Response to Referee Comments - WES Discussions

Quantifying the Impact of Modeling Fidelity on Different Substructure Concepts for Floating Offshore Wind Turbines - Part I: Validation of the Hydrodynamic Module QBlade-Ocean

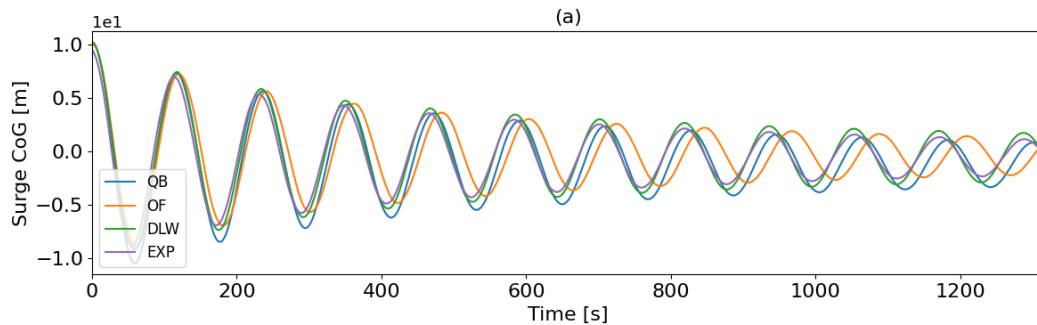
Section 4.2 – last paragraph:

The explanation for the difference in surge frequency focuses on the stiffness from the mooring system, but this was shown in Figure 3 to match very well for both numerical models and the experiment. Is it possible there is some difference in the tuning of the added mass for the two numerical models?

We agree that this explanation is misleading as stated in the manuscript since the fairlead tensions indeed are verified in Figure 3, albeit at static conditions. We can rule out the added mass modeling as the cause for the seen deviation since both QBlade and OpenFAST rely on the added mass coefficients (at infinite frequency) that are calculated in a preprocessing step within the BEM tool WAMIT instead of modeling it explicitly (as would be done in a Morison only approach) for both Softwind and OC5.

The observed difference in frequency also cannot be attributed to masses and inertias since the overall masses and inertias of the Softwind and OC5 structures were defined in accordance with the rigid body masses and inertias specified in the experimental definition. Additionally, consistent mass distribution was closely adhered to for the turbine and RNA, as well as for the assembled system CoG, between the numerical codes.

Hence, the dynamics from the mooring lines are the probable cause. MoorDyn (OpenFAST) models the lines as rigid cable segments that are connected with joints that neglect bending stiffness in a lumped mass approach. QBlade-Ocean instead models the mooring system using the absolute nodal coordinate transformation (ANCF) in CHRONO, a nonlinear finite element formulation that includes bending, torsion and shear deformation. As a possible result, both codes required different amounts of additional stiffness in the surge DoF of the OC5 model to tune it towards the experimental result ($1e+04$ N/m in QBlade compared to $5e+04$ N/m in OpenFAST).

The close agreement seen between QBlade and DeepLines Wind on the Hexafloat model (see figure below), with no additional stiffness included, further supports this thesis. DeepLines Wind, like QBlade, relies on cable elements to capture the mooring dynamics.

The deviation in natural frequency is small and we updated the manuscript to focus less on the small difference. Moreover, it is updated to state that a possible explanation could be found in the modeling of the mooring dynamics (lumped mass and no-linear cable elements).

A short summary of the explanation laid out in the comment that cites differences in the mooring modeling approach as a possible cause is now written in the corresponding section.

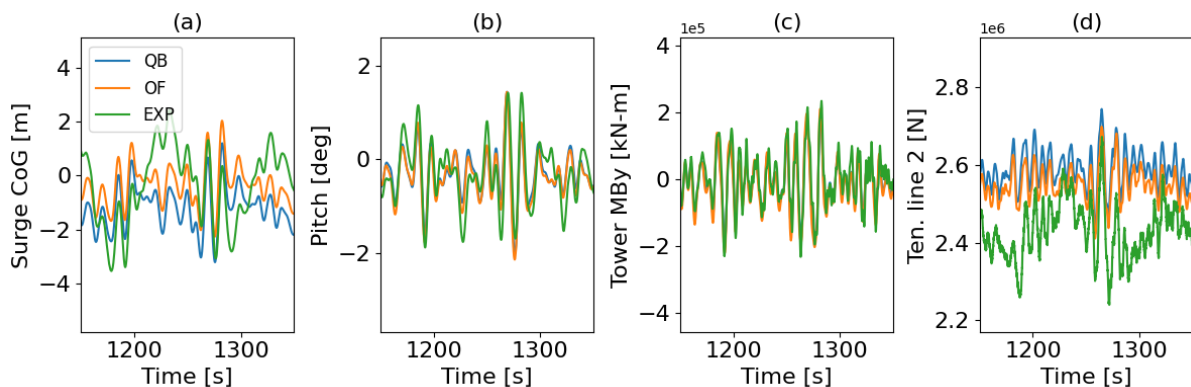
Figure 13 (now Fig 10 in the revised manuscript): It is mentioned that the difference in the wave frequency pitch motions between the numerical models and the experiment is on the order of a tenth of a degree, but the difference in range shown in the box-whisker plot appears larger than this. The difference doesn't seem negligible, and may also be related to the tuning of the viscous force coefficients from the decay tests.

We agree that the formulation in this paragraph is inviting misinterpretation, and we thank the Reviewer for pointing this out. The description that is mentioned by the Reviewer is supposed to address the comparison between QBlade and OpenFAST to each other and not, as was interpreted, between the numerical codes and the experiment. It is true that the IQR in the box-plot that corresponds to the experiment is wider compared to the numerical codes, this is a result of the non-linear motions too. This is stated just below the sentence that is addressed in the review with QBlade and OpenFAST underestimating the IQR by 16% and 10% respectively (Line 520). A time series of the corresponding test case that proves the statement concerning the difference being in the order of tenths of a degree between QBlade and OpenFAST is shown below.

The paragraph is slightly modified in the revised manuscript to clarify this point and to split the discussion between responses within the linear wave range and below it.
